RE: GRU Comments to Surficial Aquifer Interim Remedial Measure (IRM) and Soil Solidification/Stabilization Pilot Test Work Plan (September 25, 2008)

**SUBJECT:** Review of the Surficial Aquifer Interim Remedial Measure (IRM) and Soil Solidification/Stabilization Pilot Test Work Plan

TITLE: SURFICIAL AQUIFER NAPHTHALENE CONCENTRATIONS

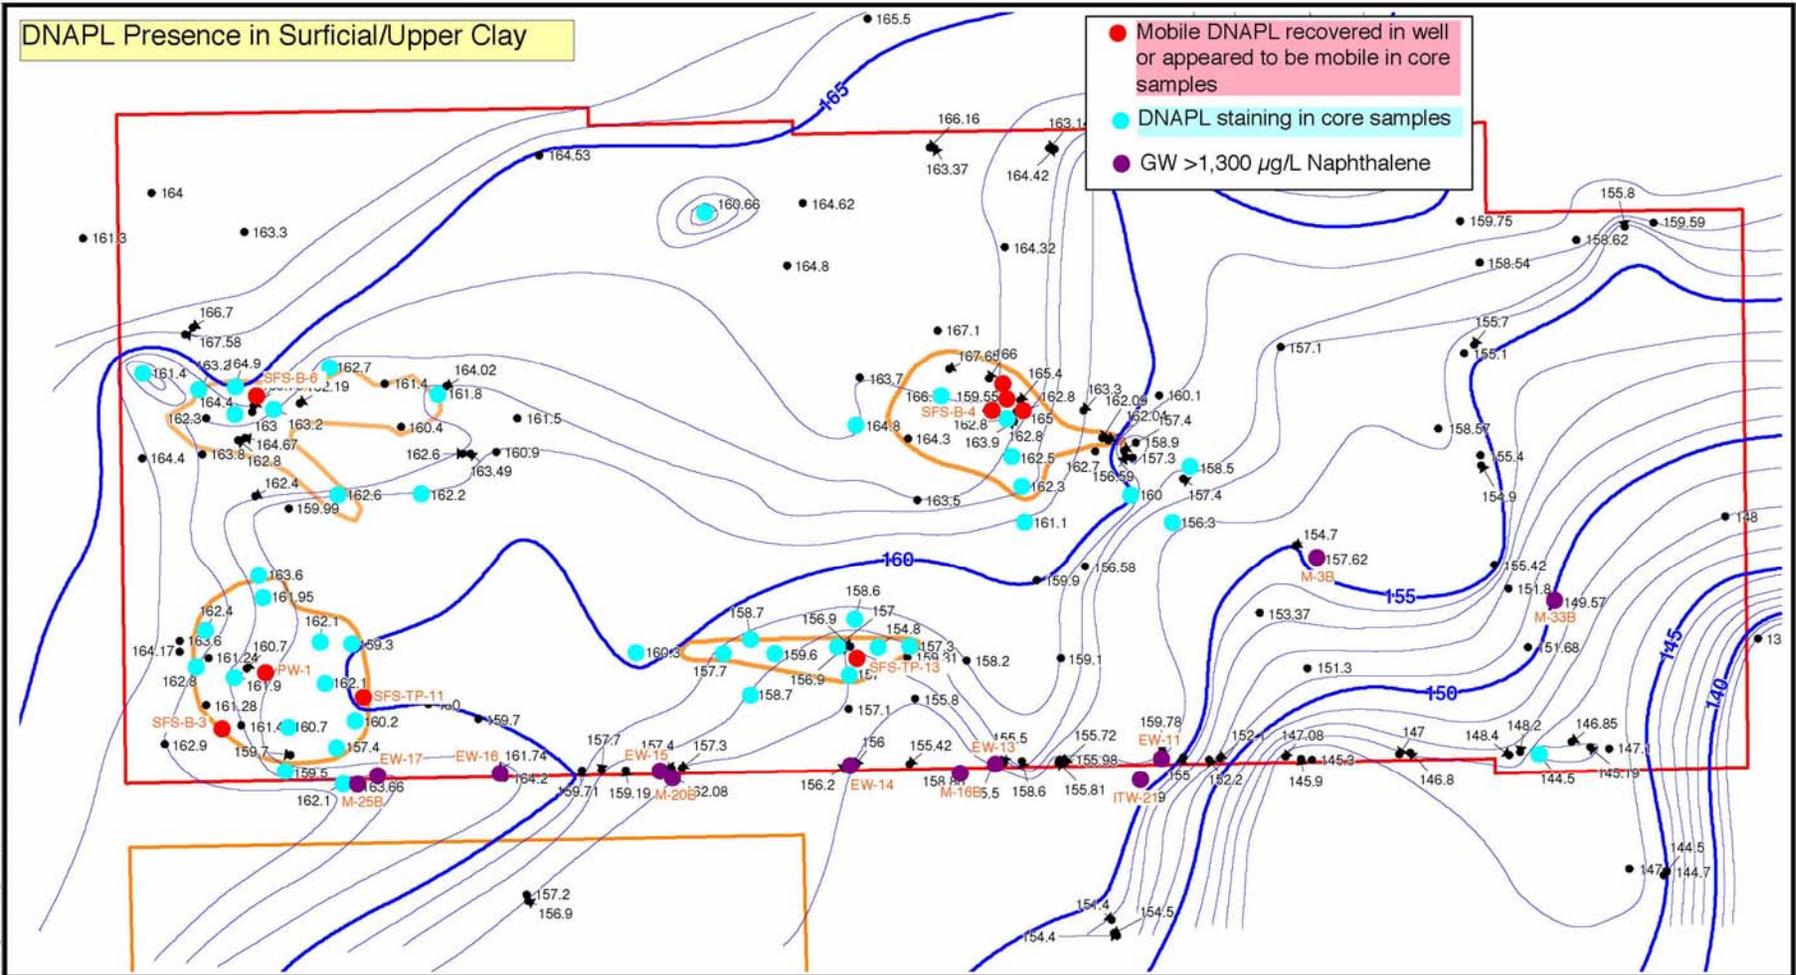
DNAPL was here in 1984 as indicated by Naphthalene at M-3 = 4100 ug/L at that time.

Approximate position of ITW-21. DNAPL was here in 1985 as indicated by naphthalene = 1320 ug/L. ITW-21 was plugged & abandoned in February 2004 when naphthalene = 5570 ug/L.

All these identified 'source zones' as identified on this map underestimate the true extent of DNAPL migration. The true extent in all aquifer zones needs to be determined before final remedies are selected.

DNAPL was here in 1984. M-25B had naphthalene = 15,000 ug/L in 1984 + PCP = 4500 ug/L.
